# **FINAL ENVIRONMENTAL ASSESSMENT**

**Residential Rock Wall in the Shoreline Setback Area  
45-010 Springer Place, Kaneʻohe, Oʻahu  
TMK 4-5-047:117**

April 2014

PROJECT NAME: Peroff Retaining Wall  
Site Plan & Detail  
CLARIFICATION SKETCH: 1  
JN #: 11.043 DATE: 4/28/14

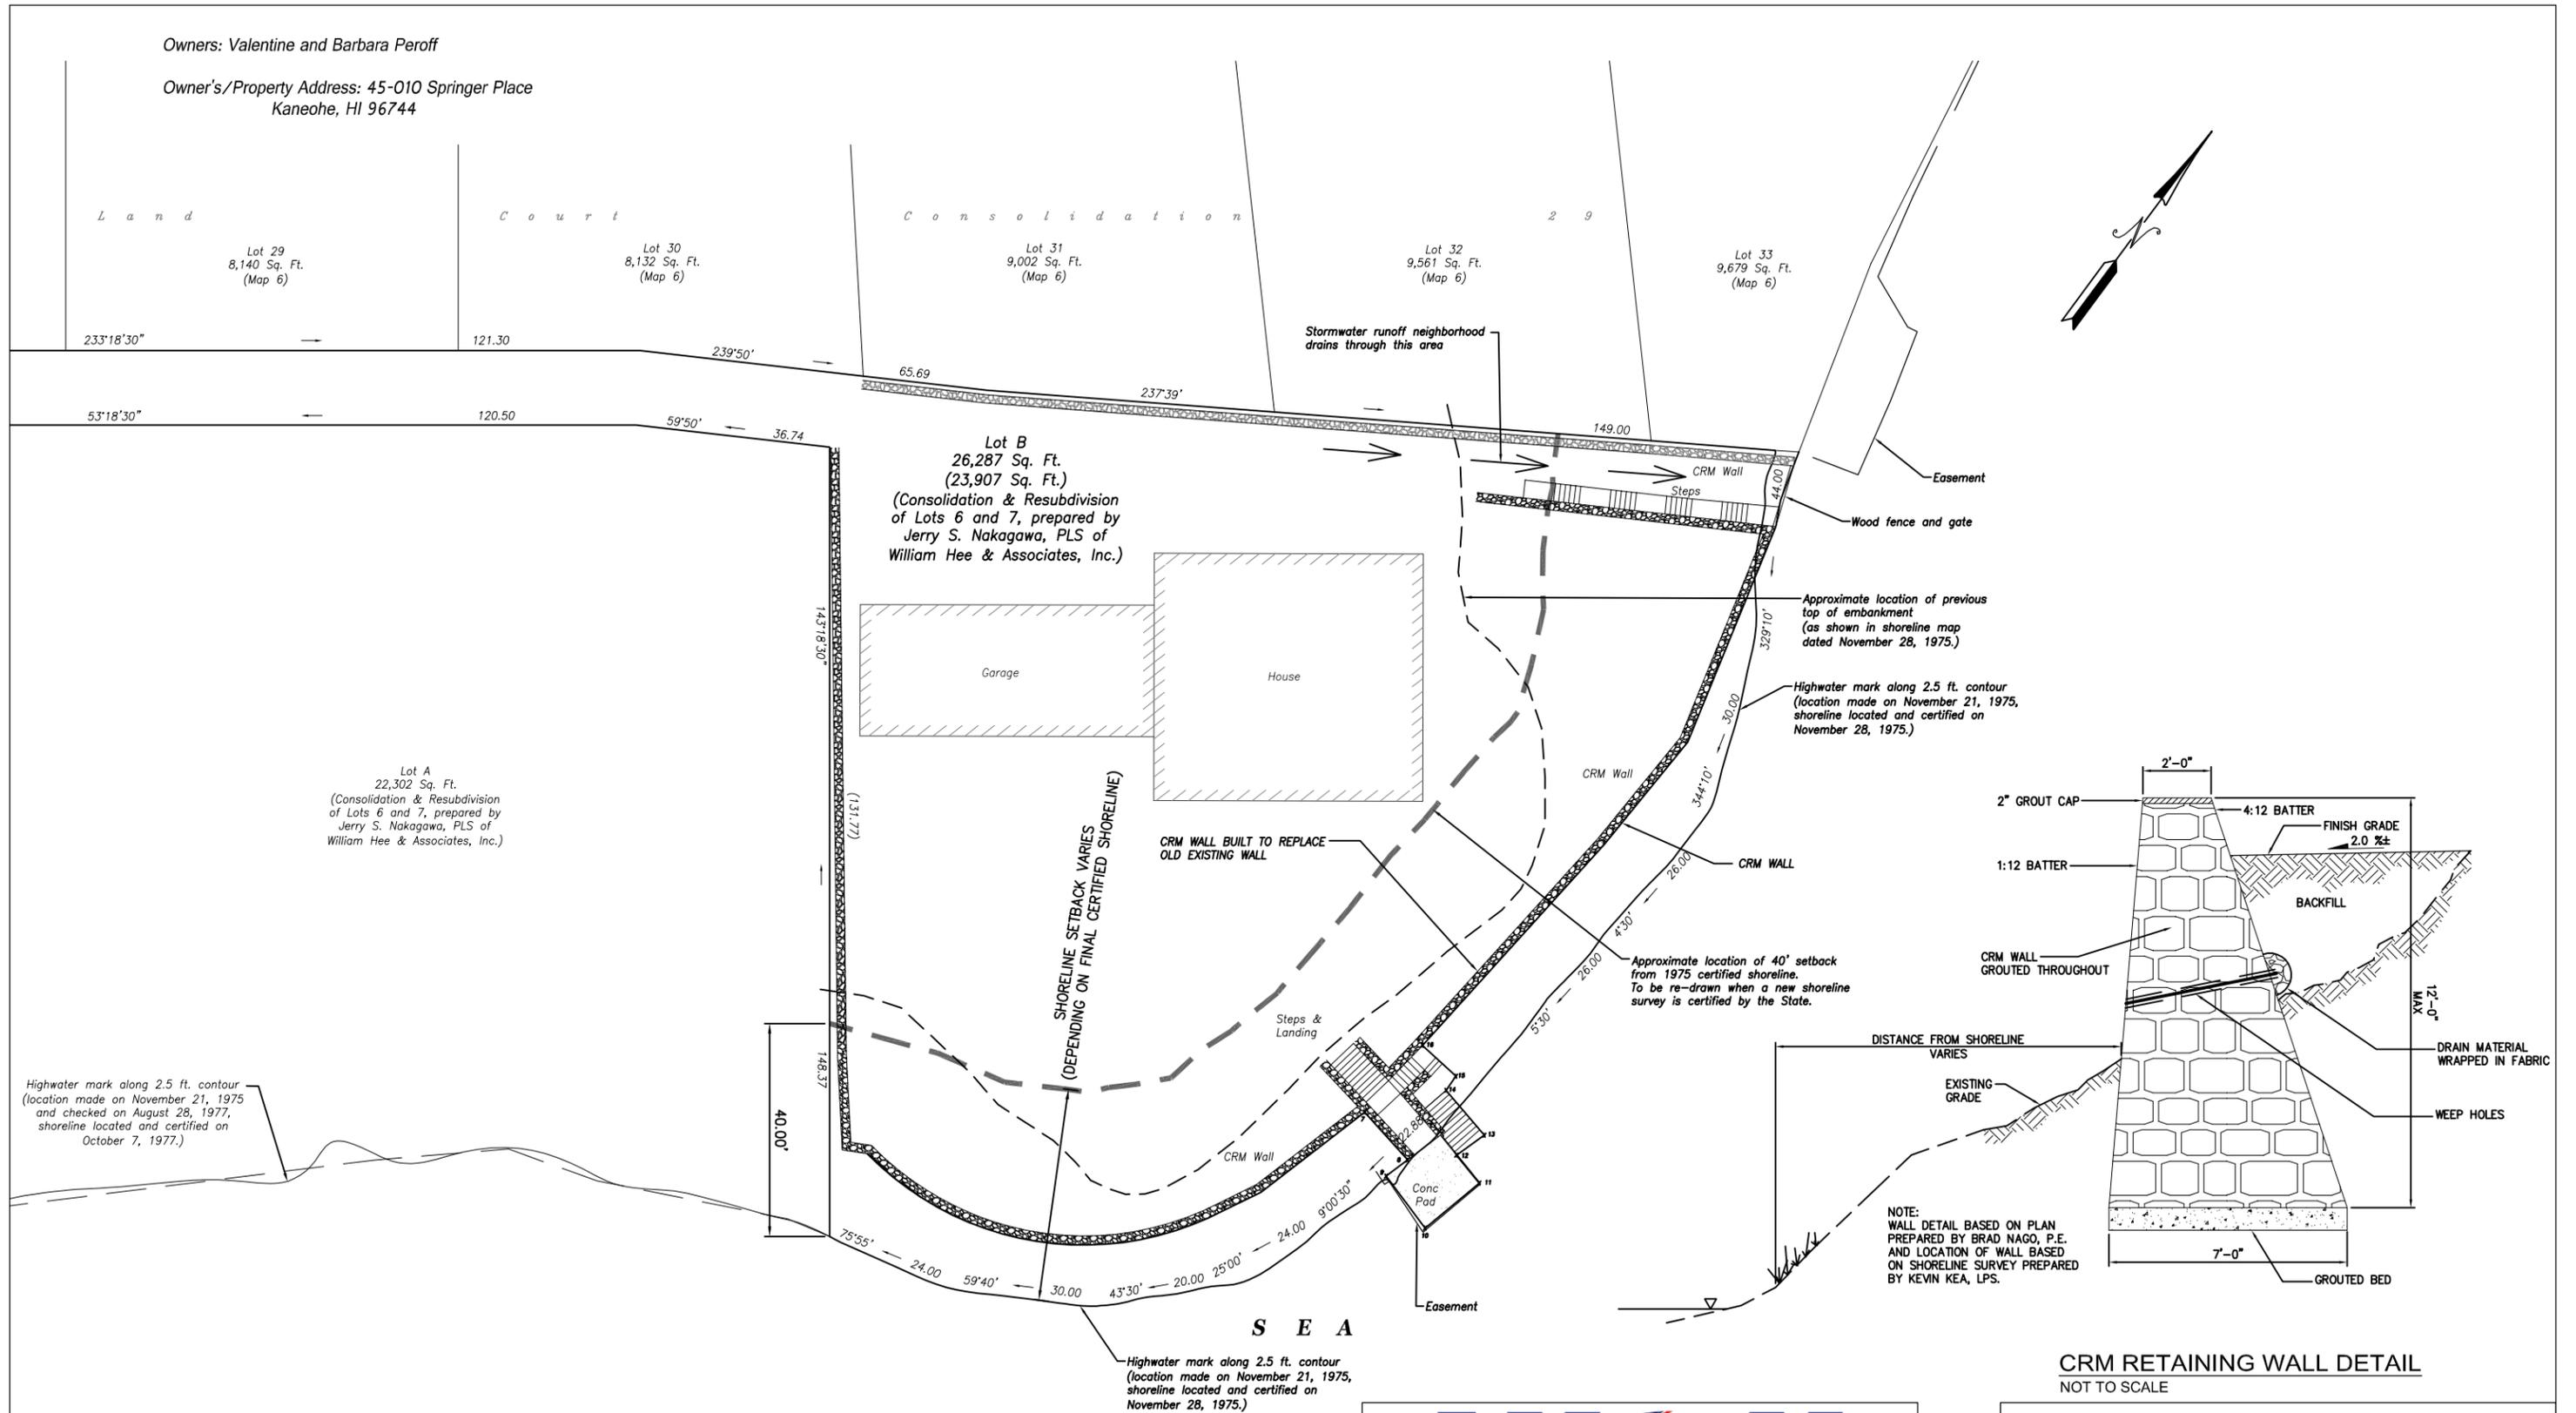
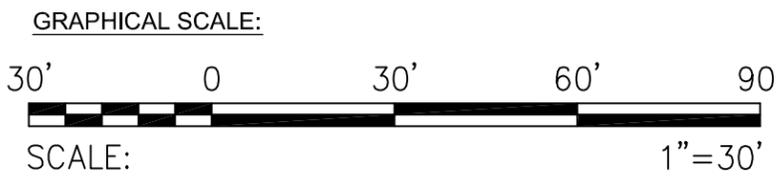
5. Appendix D. Please note that in the Site Plan & Detail, Sketch 1 drawing that the 40-foot shoreline setback line should be based on the current, presumed regulatory shoreline, and not on the November 28, 1975, certified shoreline. All structures located in the presumed 40-foot shoreline setback area are subject to review for purposes of the SSV application process.

5. A note that states, "Shoreline setback varies (depending on final certified shoreline)" has been added to Sketch 1 prepared by the project engineers.
